ACCESSIBILITY ASSESSMENT

ADA TITLE II ASSESSMENT

Owens Road
1100 Owens Road
Oxen Hill, Maryland 20745

145366.21R000-006.160

Map for Barrier ID: AX239967

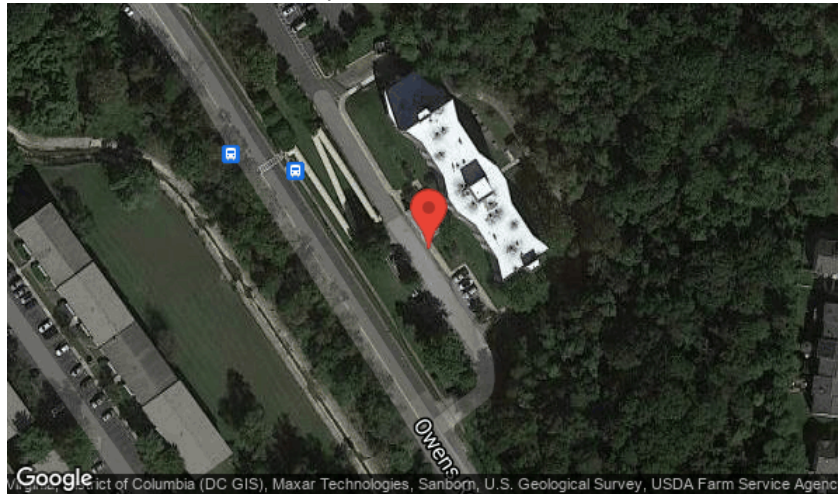
Assembly	Exterior Access Route
Type	Curb Ramp
ADA Standard	406.4
Barrier Detail	A landing at the top of the curb ramp is not present.
Location Description	Curb Ramp CR1
Observed	May 20, 2021 by Ouraccessibleworld@gmail.com
Site Conditions	A landing is not provided at the curb ramp.

Construct a landing at the top of the curb ramp. The landing clear length shall be 36" minimum. The landing clear width shall be at least as wide as the curb ramp, excluding flared sides, leading to the landing. [EXCEPTION: In alterations, where there is no landing at the top of curb ramps, curb ramp flares shall be provided and shall not be steeper than 1:12.] The slope of the landing, where the landing connects to a sidewalk aligned perpendicular or angled to the curb ramp run requiring a wheelchair turn, shall be maximum 1:48 (2.08%). Where the landing connects to a sidewalk where the path of travel continues only in the same alignment as the curb ramp run, the slope of the landing may be maximum 5%.

Photos for Barrier ID: AX239995

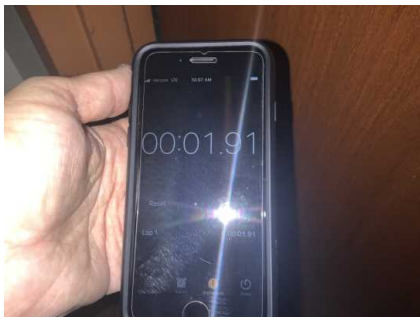
The accessible door with door closer has a sweep period of less than 5 seconds from 90 degrees to a position 12 degrees from latch and the opening force required to open the accessible, hinged, non-fire door is more than 5 pounds.

The door to the Laundry Room requires up to 14 pounds of force to operate and has a closing speed of up to 1.91 seconds from 90 degrees to a position 12 degrees from latch.

Adjust closer or remove and replace closer to ensure that the door has a closure time of at least 5 seconds within 12 degrees of the latch and that requires no more than 5 pounds of force for pushing or pulling the door open. Door closers and gate closers shall be adjusted so that from an open position of 90 degrees, the time required to move the door to a position of 12 degrees from the latch is 5 seconds minimum. The force at the latch, the force to set the door in motion, and the force to fully open the door shall be maximum 5 pounds. These forces do not apply to the force required to retract latch bolts or disengage other devices that hold the door or gate in a closed position.

Map for Barrier ID: AX239963

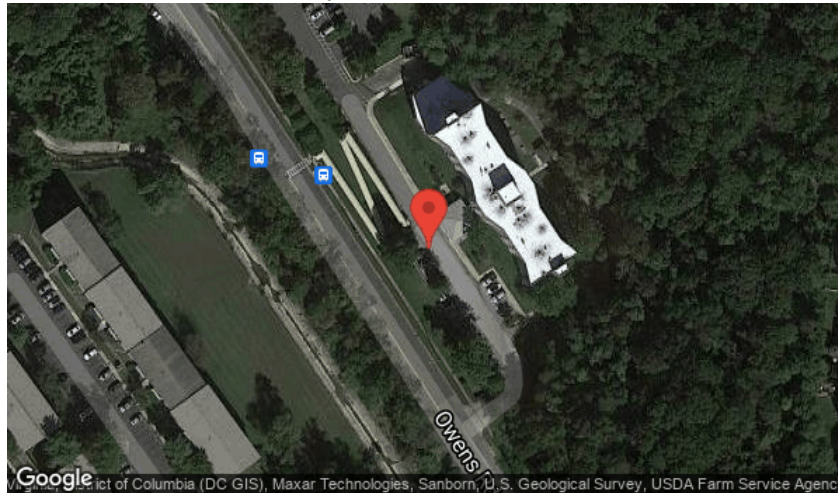
Assembly	Accessible Parking
Type	Parking Space-Van
ADA Standard	UFAS 4.6.3
Barrier Detail	A van access aisle is not provided at a van accessible space.
Location Description	Parking Lot
Observed	May 20, 2021 by Ouraccessibleworld@gmail.com
Site Conditions	The access aisle has a running slope of up to 2.3%.

Restripe and add an adjacent access aisle that is at least 96" wide. Parking spaces for disabled people shall be at least 96" wide and shall have an adjacent access aisle 60" wide minimum (see Fig. 9). [EXCEPTION: If accessible parking spaces for vans are provided, each should have an adjacent access aisle at least 96" wide.] Parking access aisles shall be part of an accessible route to the building or facility entrance. Two accessible parking spaces may share a common access aisle. Parked vehicle overhangs shall not reduce the clear width of an accessible circulation route. Parking spaces and access aisles shall be level with surface slopes not exceeding 1:50 in all directions. The quantity and order of magnitude cost estimate provided for this barrier are limited to the extent of the area identified as non-compliant. Additional costs that may be associated with removal of the barrier are not included.

Map for Barrier ID: AX239964

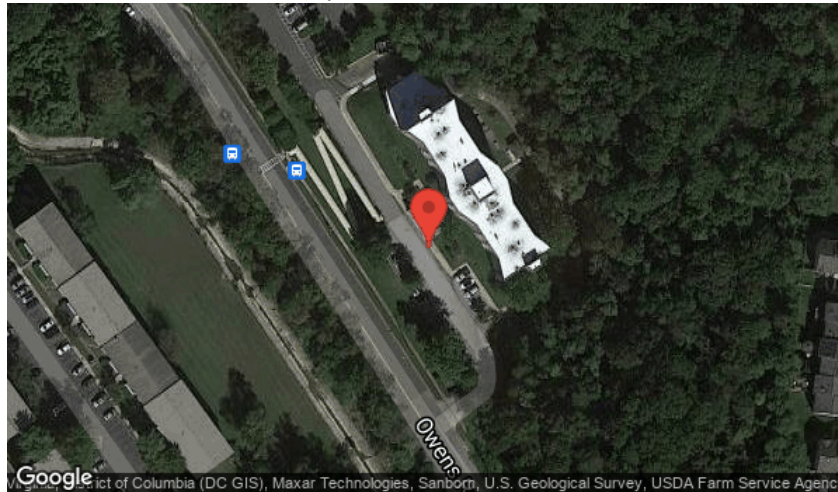
Assembly	Accessible Parking
Type	Parking Space-Van
ADA Standard	UFAS 4.6.4
Barrier Detail	The accessible van stall signage is not compliant.
Location Description	Parking Lot
Observed	May 17, 2021 by Ouraccessibleworld@gmail.com

The bottom of the accessible signage is mounted at 32" above the parking surface.

Provide signage for the van parking stall showing the International Symbol of Accessibility. Accessible parking spaces shall be designated as reserved for the disabled by a sign showing the International Symbol of Accessibility. Such signs shall not be obscured by a vehicle parked in the space. This barrier applies only to non-public parking in residential developments. Other applicable federal, state and local regulations may supercede this barrier, and have stricter requirements.

Map for Barrier ID: AX241405

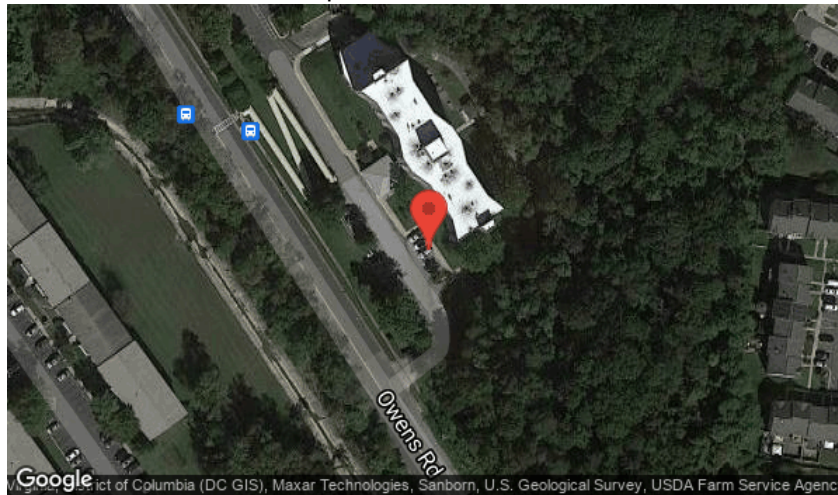
Assembly	Accessible Parking
Type	Parking Space-Car
ADA Standard	UFAS 4.6.3
Barrier Detail	An access aisle is not provided.
Location Description	Parking Lot A - Space P1-A, P1-B, P1-C, P1-D
Observed	May 16, 2018 by silloyd
Site Conditions	The parking space does not have an access aisle.

Re-stripe and add an adjacent access aisle that is at least 60" wide and has a slope of less than 2% in all directions.

Map for Barrier ID: AX241393

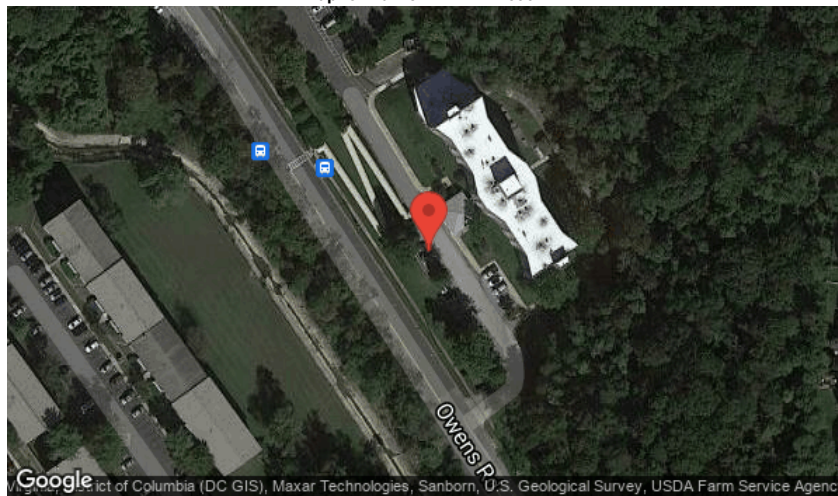
Assembly	Accessible Parking
Type	Parking Space-Car
ADA Standard	UFAS 4.6.3
Barrier Detail	The access aisle slope is greater than 2%.
Location Description	Parking Lot A - Space P2-A, P2-C
Observed	May 16, 2018 by silloyd

The cross slope of the access aisle at P2-A is 4.0%. The running slope of the access aisle at P2-C is 2.2%.

Remove and replace with an adjacent access aisle that is at least 60" wide and has a slope 2% in all directions. Parking spaces and access aisles shall be level with surface slopes not exceeding 1:50 in all directions. Parking access aisles shall be part of an accessible route to the building or facility entrance. Parked vehicle overhangs shall not reduce the clear width of an accessible circulation route. The quantity and order of magnitude cost estimate provided for this barrier are limited to the extent of the area identified as non-compliant. Additional costs that may be associated with removal of the barrier are not included.

Map for Barrier ID: AX241397

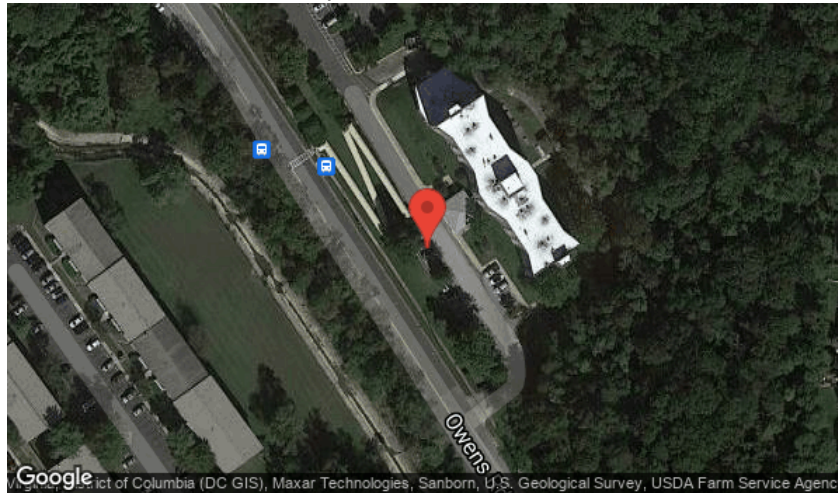
Assembly	Accessible Parking
Type	Parking Space-Car
ADA Standard	UFAS 4.6.3
Barrier Detail	The slope of the parking space is more than 2% running/cross slope.
Location Description	Parking Lot A - Space P2-A, P2-D
Observed	May 16, 2018 by siloyd

The cross slope of space P2-A is 3.0% and the running slope is 7.1%. The cross slope of space P2-B is 4.5% and the running slope is 3.7%.

Remove and replace with a parking space that has no more than 2% slope in all directions. Parking spaces and access aisles shall be level with surface slopes not exceeding 1:50 in all directions. Parking access aisles shall be part of an accessible route to the building or facility entrance. Parked vehicle overhangs shall not reduce the clear width of an accessible circulation route. The quantity and order of magnitude cost estimate provided for this barrier are limited to the extent of the area identified as non-compliant. Additional costs that may be associated with removal of the barrier are not included.

Map for Barrier ID: AX239960

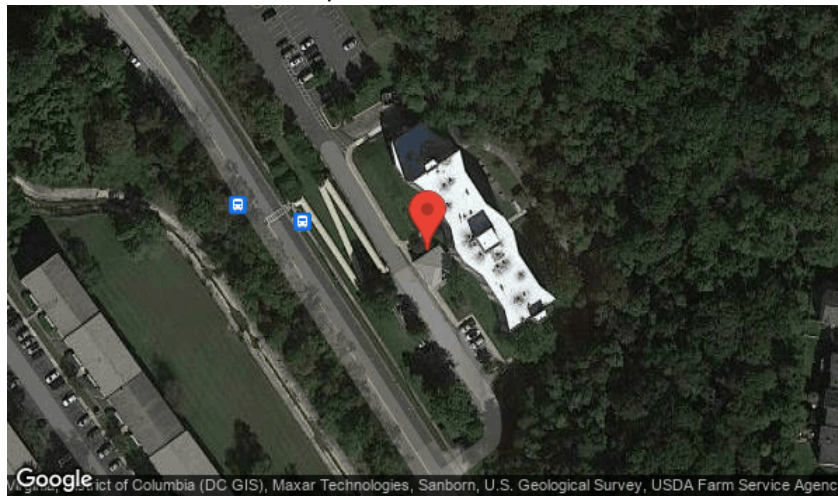
Assembly	Exterior Access Route
Type	Ramp
ADA Standard	405.2

The ramp has a running slope in excess of 1:12 (8.33%) and/or cross slope in excess of 1:48 (2.08%).

Remove the existing ramp and provide a compliant ramp. Ramp runs shall have a running slope not steeper than 1:12 (8.33%). [EXCEPTION: In existing sites, buildings, and facilities built before January 1992, ramps shall be permitted to have running slopes steeper than 1:12 where such slopes are necessary due to space limitations. Where slopes are steeper than 1:10 but not steeper than 1:8, the rise shall be 3" maximum. Where slopes are steeper than 1:12 but not steeper than 1:10, the rise shall be 6" maximum.] Ramp runs shall have cross slopes not greater than 1:50 (2%). [EXCEPTION: Cross slopes not greater than 1:48 (2.08%) are permitted.] Either regrade to a maximum running slope of 1:20 (5%) for the walking surface, or provide a compliant ramp. The cost estimate for this barrier removal is based on providing a compliant ramp. The quantity and order of magnitude cost estimate provided for this barrier are limited to the extent of the area identified as non-compliant. Additional costs that may be associated with removal of the barrier are not included.

Map for Barrier ID: AX239958

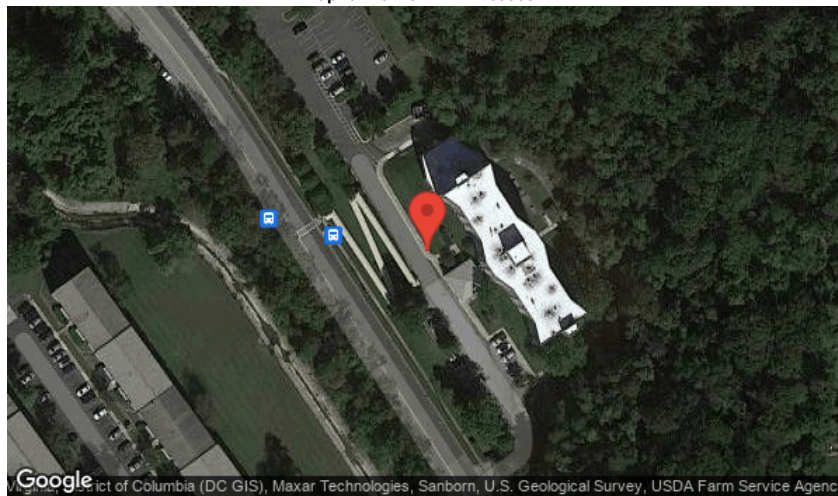
Assembly	Exterior Access Route
Type	Exterior Accessible Route
ADA Standard	403.3
Barrier Detail	The accessible route has cross slopes greater than 1:50 (2%).
Location Description	Sidewalk to Entrance on North Side from Stair ST1
Observed	May 20, 2021 by Ouraccessibleworld@gmail.com

The walkway should be graded to a maximum 1:50 (2%) cross slope. An accessible route has maximum 1:20 (5%) running slope and maximum 1:50 (2%) cross slope. [EXCEPTION: Cross slopes not exceeding 1:48 (2.08%) are permitted.] The clear width of walking surfaces shall be 36" minimum. [EXCEPTION: The clear width shall be permitted to be reduced to 32" minimum for a length of 24" maximum provided that reduced width segments are separated by segments that are 48" long minimum and 36" wide minimum.] Where grading to maximum running slope of 1:20 (5% running slope) is not possible, provide a compliant ramped surface within the walkway with maximum slope 1:12 (8.33%) and maximum ramp run rise of 6" without handrails. If a ramped surface with running slopes greater than 1:20 (5%) and maximum 1:12 (8.33%) rises more than 6", handrails are required. The cost estimate for this barrier removal is based on grading the running slope to maximum 1:20 (5%). The quantity and order of magnitude cost estimate provided for this barrier are limited to the extent of the area identified as non-compliant. Additional costs that may be associated with removal of the barrier are not included.

Map for Barrier ID: AX239949

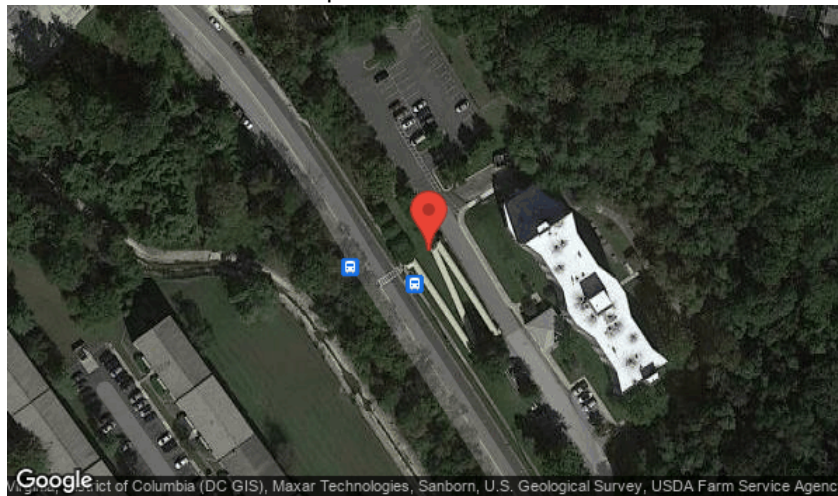
Assembly	Exterior Access Route
Type	Exterior Accessible Route
ADA Standard	304; 403.5.2
Barrier Detail	A compliant turning space is not provided at a change of direction.
Location Description	Sidewalk to Street - top landing
Observed	May 20, 2021 by Ouraccessibleworld@gmail.com

Provide a compliant turning space at the change of direction. Floor or ground surfaces of a turning space shall be level. Changes in level are not permitted. [EXCEPTION: Slopes not steeper than 1:48 shall be permitted] [Advisory 304.2 Floor or Ground Surface Exception. As used in this section, the phrase "changes in level" refers to surfaces with slopes and to surfaces with abrupt rise exceeding 1/2" which are not ramped. Such changes in level are prohibited in required clear floor and ground spaces, turning spaces, and in similar spaces where people using wheelchairs and other mobility devices must park their mobility aids such as in wheelchair spaces, or maneuver to use elements such as at doors, fixtures, and telephones. The exception permits slopes not steeper than 1:48.] Turning space shall be either a circular space or a T-shaped space. The circular turning space shall be a space of 60" diameter minimum. The space shall be permitted to include knee and toe clearance. The T-shaped turning space shall be a T-shaped space within a 60 inch square minimum, with arms and base 36" wide minimum. Each arm of the T shall be clear of obstructions 12" minimum in each direction and the base shall be clear of obstructions 24" minimum. The space shall be permitted to include knee and toe clearance only at the end of either the base or one arm. Clear Width at 180 Degree Turn: Where the accessible route makes a 180 degree turn around an element which is less than 48" wide, clear width shall be 42" minimum approaching the turn, 48" minimum at the turn and 42" minimum leaving the turn. [EXCEPTION: Where the clear width at the 180 degree turn is 60" minimum, then the dimensional requirements for a 180 degree turn shall not be required.] The quantity and order of magnitude cost estimate provided for this barrier are limited to the extent of the area identified as non-compliant. Additional costs that may be associated with removal of the barrier are not included.

Map for Barrier ID: AX239952

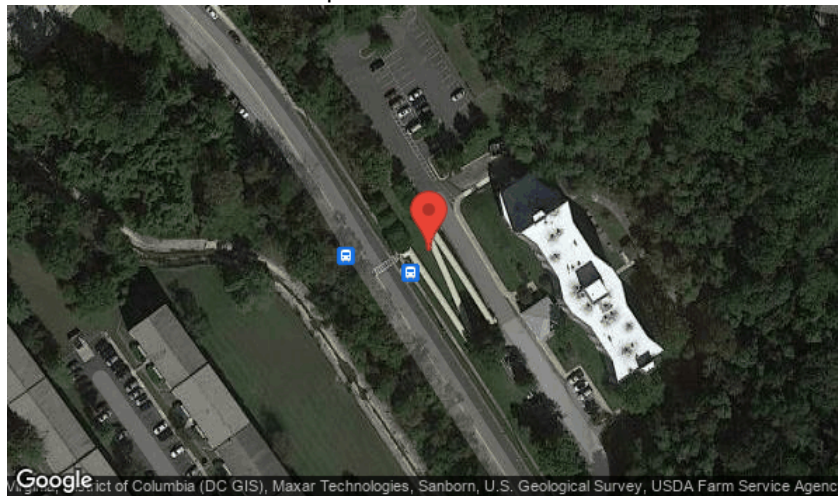
Assembly	Exterior Access Route
Type	Exterior Accessible Route
ADA Standard	304; 403.5.2
Barrier Detail	A compliant turning space is not provided at a change of direction.
Location Description	Sidewalk to Street street landing
Observed	May 21, 2021 by Ouraccessibleworld@gmail.com

Provide a compliant turning space at the change of direction. Floor or ground surfaces of a turning space shall be level. Changes in level are not permitted. [EXCEPTION: Slopes not steeper than 1:48 shall be permitted] [Advisory 304.2 Floor or Ground Surface Exception. As used in this section, the phrase "changes in level" refers to surfaces with slopes and to surfaces with abrupt rise exceeding 1/2" which are not ramped. Such changes in level are prohibited in required clear floor and ground spaces, turning spaces, and in similar spaces where people using wheelchairs and other mobility devices must park their mobility aids such as in wheelchair spaces, or maneuver to use elements such as at doors, fixtures, and telephones. The exception permits slopes not steeper than 1:48.] Turning space shall be either a circular space or a T-shaped space. The circular turning space shall be a space of 60" diameter minimum. The space shall be permitted to include knee and toe clearance. The T-shaped turning space shall be a T-shaped space within a 60 inch square minimum, with arms and base 36" wide minimum. Each arm of the T shall be clear of obstructions 12" minimum in each direction and the base shall be clear of obstructions 24" minimum. The space shall be permitted to include knee and toe clearance only at the end of either the base or one arm. Clear Width at 180 Degree Turn: Where the accessible route makes a 180 degree turn around an element which is less than 48" wide, clear width shall be 42" minimum approaching the turn, 48" minimum at the turn and 42" minimum leaving the turn. [EXCEPTION: Where the clear width at the 180 degree turn is 60" minimum, then the dimensional requirements for a 180 degree turn shall not be required.] The quantity and order of magnitude cost estimate provided for this barrier are limited to the extent of the area identified as non-compliant. Additional costs that may be associated with removal of the barrier are not included.

Map for Barrier ID: AX239953

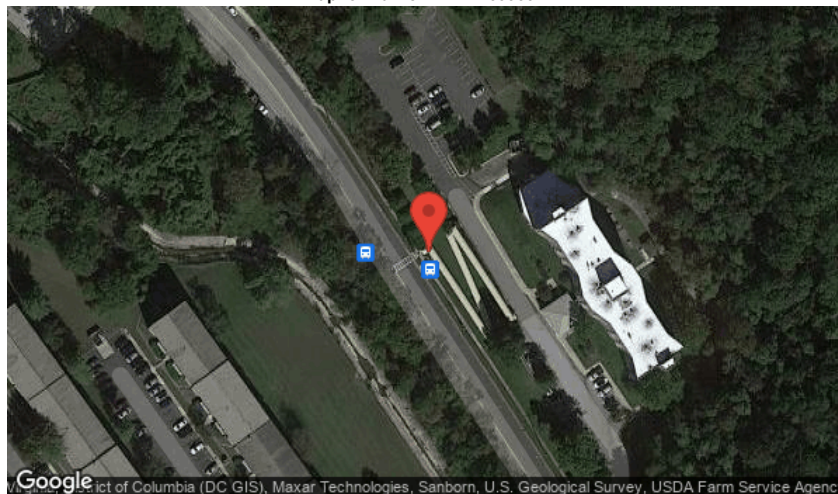
Assembly	Exterior Access Route
Type	Ramp
ADA Standard	405, 505
Barrier Detail	The ramp is required but not provided.
Location Description	Sidewalk to Street street landing
Observed	May 20, 2021 by Ouraccessibleworld@gmail.com

Provide a compliant ramp or reduce the walking surface to maximum 1:20 (5%) running slope. The cost estimate for this barrier removal is based on providing a ramp, rather than grading the running slope to maximum 1:20 (5%). Ramp runs shall have a running slope not steeper than 1:12, and a cross slope not steeper than 1:48. [EXCEPTION: In existing sites built pre-1/26/92, buildings, and facilities, ramps shall be permitted to have running slopes steeper than 1:12 where such slopes are necessary due to space limitations. Where slopes are steeper than 1:10 but not steeper than 1:8, the rise shall be 3" maximum. Where slopes are steeper than 1:12 but not steeper than 1:10, the rise shall be 6" maximum.] The clear width of a ramp run and, where handrails are provided, the clear width between handrails shall be 36" minimum. The clear width of a ramp run and, where handrails are provided, the clear width between handrails shall be 36" minimum. [EXCEPTION: Within employee work areas, the required clear width of ramps that are a part of common use circulation paths shall be permitted to be decreased by work area equipment provided that the decrease is essential to the function of the work being performed.] Ramp runs shall have maximum 30" rise. Ramp landings shall be located at the top and bottom of ramp runs, and at turns of ramp direction. Landings shall be 1:48 maximum slope in any direction. Landings shall be minimum 60" length, and as wide as the ramp run, except ramp landings at turns which shall be minimum 60" x 60" minimum. All ramp runs with a rise of 6" or greater shall have handrails on each side of the ramp. Handrails shall be compliant. The top of the handrail gripping surface shall be 34" minimum to 38" maximum vertically above the ramp surface. Provide edge protection on the sides of each ramp run which rises more than 6" and on ramp landings. Compliant edge protection shall be provided on each side of ramp runs and at each side of ramp landings. Compliant edge protection is EITHER a curb or barrier that prevents the passage of a 4" diameter sphere where the sphere is within 4" of the ramp surface OR an extension of the ramp surface 12" minimum beyond the inner face of the rail. [EXCEPTIONS: 1. Edge protection shall not be required on ramps that are not required to have handrails and have sides. 2. Edge protection shall not be required on the sides of ramp landings serving an adjoining ramp run or stairway. 3. Edge protection shall not be required on the sides of ramp landings having a vertical drop-off of 1/2" maximum within 10" horizontally of the minimum required landing area.] Ramps and their approaches shall be designed so that water will not accumulate on walking surfaces.

Map for Barrier ID: AX240478

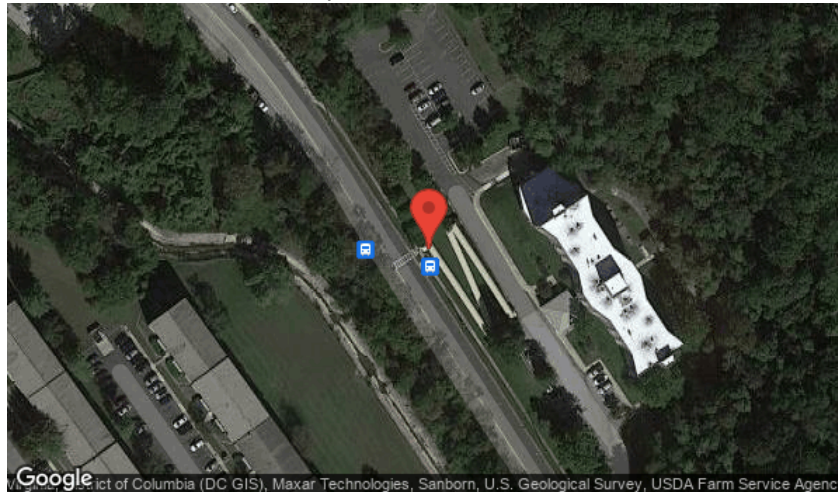
Assembly	Exterior Access Route
Type	Ramp
ADA Standard	405.8 and 505
Barrier Detail	The ramp run has a rise greater than 6"; however, handrails are not provided.
Location Description	Sidewalk to Street street landing
Observed	May 20, 2021 by Ouraccessibleworld@gmail.com
Site Conditions	The ramp has a rise of 12" and does not have handrails.

Provide compliant handrails or provide ramp runs with maximum 6" rise. Handrails are required on ramp runs which rise more than 6". Replace with continuous handrails at a consistent height above the ramp on both sides of the ramp. Inside handrails on switchback or dogleg stairs and ramps shall be continuous between runs. Top of gripping surfaces of handrails shall be 34" minimum and 38" maximum vertically above ramp surfaces. Handrails shall be at a consistent height above ramp surfaces. Clearance between handrail gripping surfaces and adjacent surfaces shall be 1-1/2" minimum. Handrail gripping surfaces shall be continuous along their length and shall not be obstructed along their tops or sides. The bottoms of handrail gripping surfaces shall not be obstructed for more than 20% of their length. Where provided, horizontal projections shall occur 1-1/2" minimum below the bottom of the handrail gripping surface. [EXCEPTIONS: 1. Where handrails are provided along walking surfaces with slopes not steeper than 1:20, the bottoms of handrail gripping surfaces shall be permitted to be obstructed along their entire length where they are integral to crash rails or bumper guards. 2. The distance between horizontal projections and the bottom of the gripping surface shall be permitted to be reduced by 1/8" for each 1/2" of additional handrail perimeter dimension that exceeds 4".] Handrail gripping surfaces with a circular cross section shall have an outside diameter of 1-1/4" minimum and 2" maximum. Handrail gripping surfaces with a non-circular cross section shall have a perimeter dimension of 4" minimum and 6-1/4" maximum, and a cross-section dimension of 2-1/4" maximum. Handrail gripping surfaces and any surfaces adjacent to them shall be free of sharp or abrasive elements and shall have rounded edges. Handrails shall not rotate within their fittings. Handrail gripping surfaces shall extend beyond and in the same direction of ramp runs. [EXCEPTIONS: 1. Extensions shall not be required for continuous handrails at the inside turn of switchback or dogleg ramps AND 3. In alterations, full extensions of handrails shall not be required where such extensions would be hazardous due to plan configuration.] Ramp handrails shall extend horizontally above the landing for 12" minimum beyond the top and bottom of ramp runs. Extensions shall return to a wall, guard, or the landing surface, or shall be continuous to the handrail of an adjacent ramp run.

Map for Barrier ID: AX239950

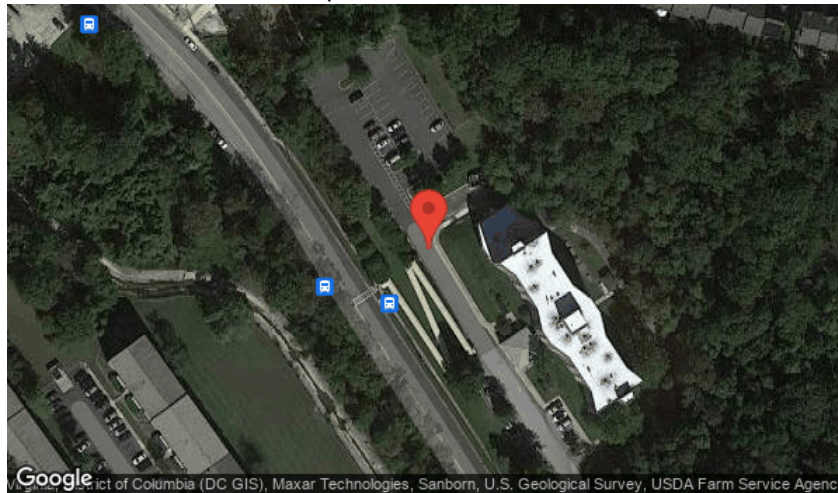
Assembly	Exterior Access Route
Type	Exterior Accessible Route
ADA Standard	302.3
Barrier Detail	The accessible route has gaps in the surface greater than 1/2" wide.
Location Description	Sidewalk to Street top landing
Observed	May 20, 2021 by Ouraccessibleworld@gmail.com
